SERVICE *No. 924* BULLETIN

Piper Aircraft Corporation
Vero Beach, Florida, U S A

Date September 13, 1989 S

SUBJECT: Shimmy Dampener Replacement

SKETCH "A"

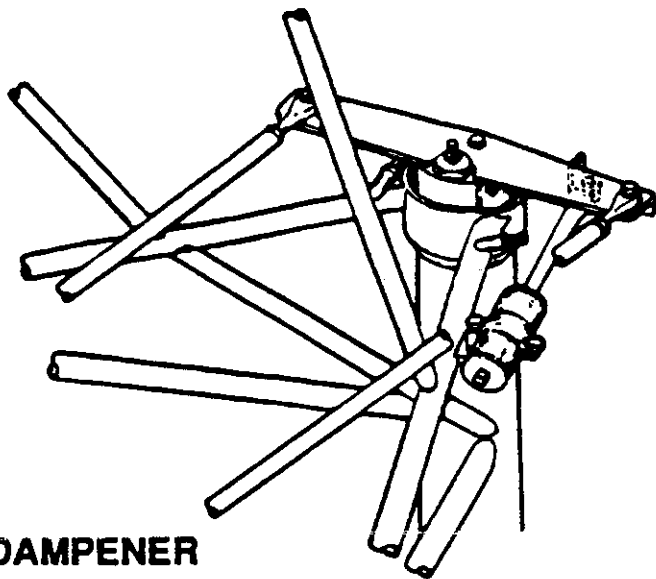
1. Remove cowlings as necessary to gain access to nose wheel shimmy dampener. Refer to applicable Owners Manual or Parts Catalog.
2. Shimmy Dampeners with Piper Part Number 13086-00, as identified on Sketch A (attached), should be removed, discarded and replaced by Piper Part Number 21701-06.

This Service Bulletin recommends the shimmy dampener currently installed in the affected model aircraft be replaced by a new Shimmy Dampener, Piper Part Number 21701-06, and provides instructions for continuing maintenance at regular intervals.

SKETCH "B"

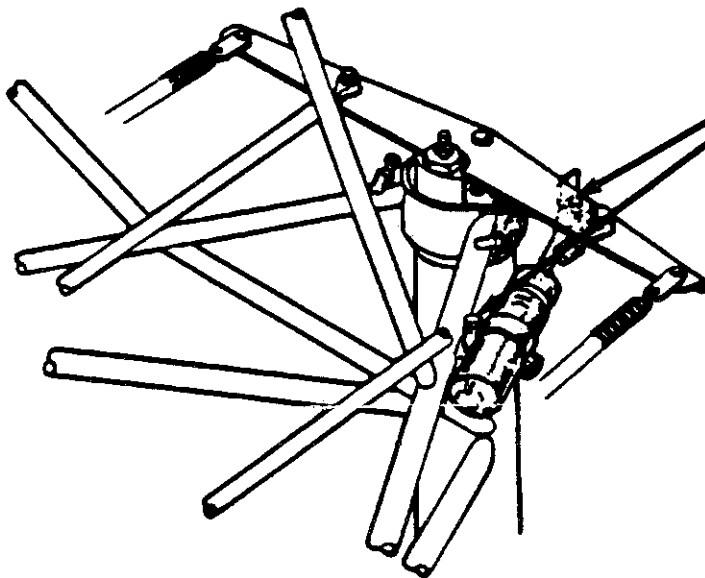
3. If the shimmy dampeners with Piper Part Numbers 21701-02 and 21701-04, Sketch B (attached), are inspected and determined to be serviceable and airworthy and the instructions below are complied with, those shimmy dampeners may be returned to service.

4. Determine that nose wheel travel is 20 degrees left and right of center.
5. Determine that the shimmy dampener rotates freely on the axis of its attachment bolt throughout its full travel, especially as it approaches the limits of nose wheel travel.

6. Determine that the attachment of the shimmy dampener rod end to the nose wheel steering arm is free to accept angular travel in either direction.
7. Should any stiffness, restrictions, or other maladies be noticed, correct by replacing parts and adjusting as necessary until proper fit and function is obtained.

8. A regular maintenance routine of inspection, cleaning, and lubrication should be performed at each one hundred (100) hours of operation or at any inspection event. Lubricate shimmy dampener rod end and pivot point using general purpose low temperature oil (MIL-L-7870 or equivalent). Wipe shimmy dampener shaft using a clean cloth saturated with MIL-H-5606 hydraulic fluid.
